**Subject: Response to Request for Additional Information for the Review of the GE Hitachi Nuclear Energy, Morris Operation, Topical Report NEDE-31559, "GE Hitachi Nuclear Energy Quality Assurance Plan Morris Operation," (CAC No. L25119)**

Response to NRC Request for Additional Information (RAI)

**GEH Quality Assurance Plan, Morris Operation**

**FIGURE 1: MORRIS OPERATION ORGANIZATION**  
(Operations below dotted line are represented at GEH Morris)

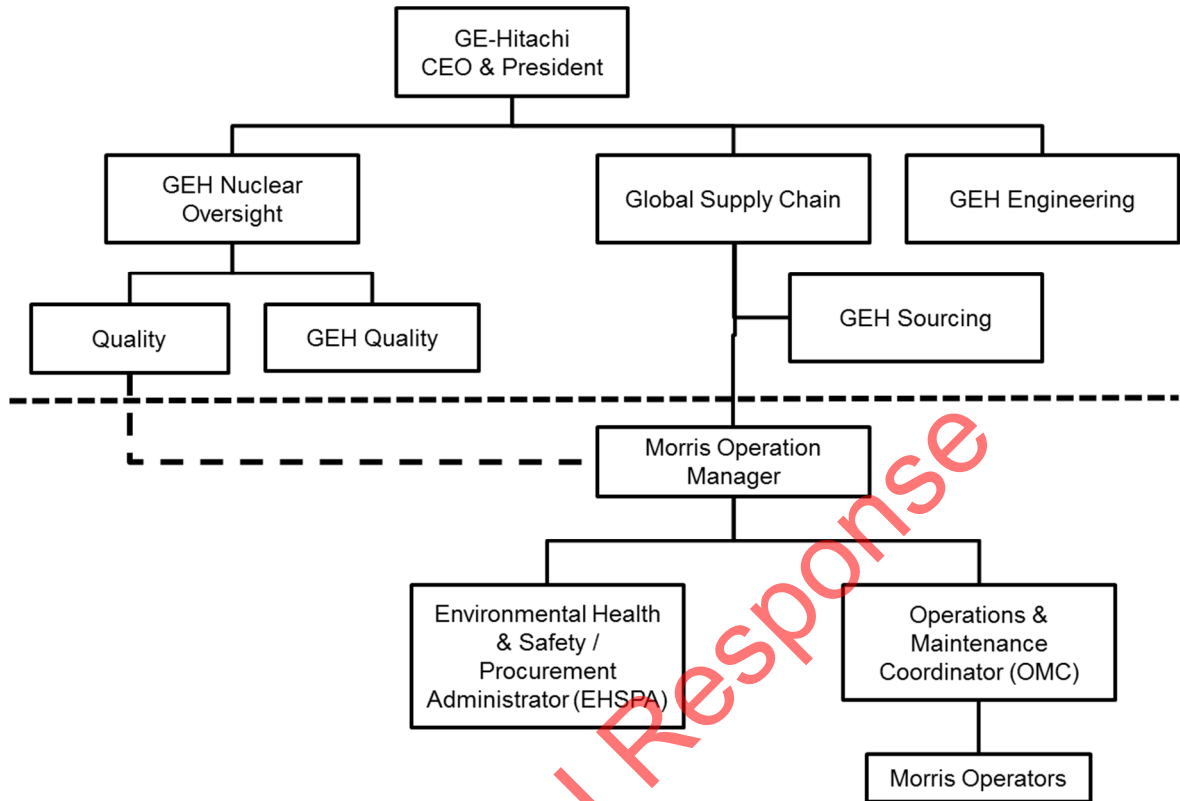
Section	Summary of Change
Policy Statement	Changed the name to the current Vice President, Emily Martin (Not Related to RAI)
Section 1	
1.4.4	Added text to clarify Quality activities and responsibilities. (Not Related to RAI)
1.4.5	Changed QA to Quality consistent with the current organization (Not Related to RAI) Deleted Item (i) regarding 10 CFR Part 71 activities
Figure 1	Modified to reflect the proper location of the Quality organization (Not Related to RAI)
